APPLICATION NO.	FILING DATE	FIRST NAMED INVENTOR	ATTORNEY DOCKET NO.	CONFIRMATION NO.
10/809,977	03/26/2004	Edward Lopatinsky		7910
7590	06/05/2006			EXAMINER PAPE, ZACHARY
ROTYS INC. 5450 COMPLEX ST. # 313 SAN DIEGO, CA 92123			ART UNIT 2835	PAPER NUMBER

Office Action Summary	Application No.	Applicant(s)
	10/809,977	LOPATINSKY ET AL.
	Examiner	Art Unit
	Zachary M. Pape	2835

DETAILED ACTION

Fig 1

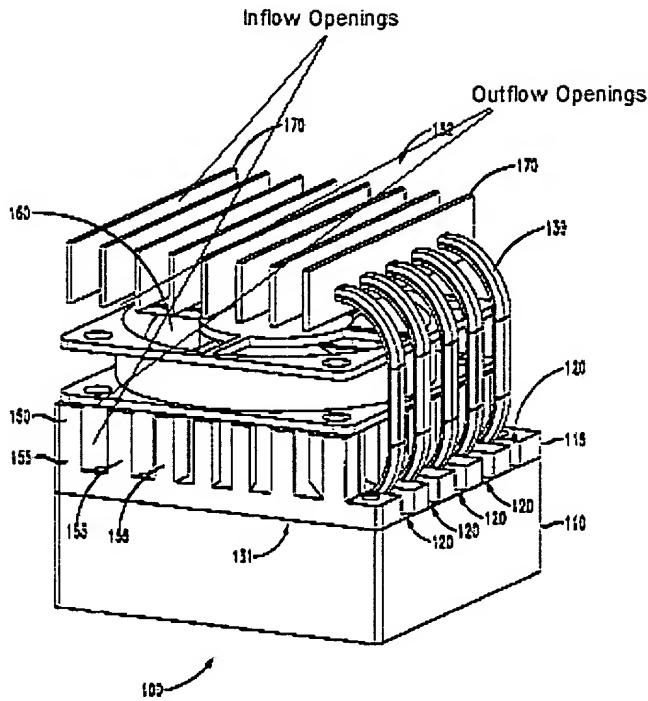
With respect to claim 1, Chen et al. teaches a cooler (100) for cooling of electronic components comprising at least two heat sinks (150, 170) thermally connected with each other by heat spreading means (130), said cooler (100) is thermally connected with said electronic component (110), wherein: each of said heat sinks comprising inflow and outflow openings (See present office action Fig 1 below), and thermally connected heat exchanging means (155, 170) and a base (115, and the bottom of fins 170); and a blower (160) located between said heat sinks. Chen et al. fails to teach a double inlet centrifugal blower comprising a casing with two inlets and an outlet, a radial impeller with an axle and an electric drive, said impeller comprising radial-blades located from both sides of an impeller disk, and that each of said outflow openings is coincided with said closest inlet, so cooling air flows through said inflow openings, said heat exchanging means, said outflow openings and said inlets of said blower in a series way. Smith teaches the conventionality of using a double inlet centrifugal blower (58) with two inlets and an outlet (As illustrated in Fig 6, the air enters

the top and the bottom of 58), a radial impeller (Column 4, Lines 16-18) with an axle (As illustrated in Fig 6) and an electric drive (60), said impeller comprising radial-blades located from both sides of an impeller disk (As illustrated in Fig 6). It would have been obvious to one of ordinary skill in the art at the time the invention was made to combine the teachings of Smith with that of Chen et al. to provide an efficient and quiet blower to the device of Chen et al. (Smith: Column 4, Lines 24-26). With respect to the airflow direction, utilizing the blower of Smith with the cooler of Chen et al. would result in the outflow openings coinciding with the closest inlet so cooling air flows through the inflow openings, through the heat exchange means, through the outflow openings and into the inlets of the blower (See Fig 6 of Smith which illustrates that air flows into the top and the bottom of the blower such that the air would flow into the inflow openings of the cooler of Chen et al.).

With respect to claim 3, Chen et al. further teaches that the heat spreading means (130) are made of at least one heat pipe comprising evaporator and condenser parts (Column 4, Lines 51-65) that thermally connected with said bases of two different heat sinks (As illustrated in Fig 1).

With respect to claim 4, Chen et al. further teaches that the heat spreading means (130) are made as a high heat conductive plate (One of ordinary skill in the art would construct the heat spreading means (130) of a highly heat conductive plate. See Chen et al. Column 2, Lines 50-53.) located from one side of and perpendicularly to said bases (As illustrated in Fig 1).

With respect to claim 7, Chen et al. further teaches that the heat exchanging means are upstanding pins and/or fins contacting said base (As illustrated in Fig 1).
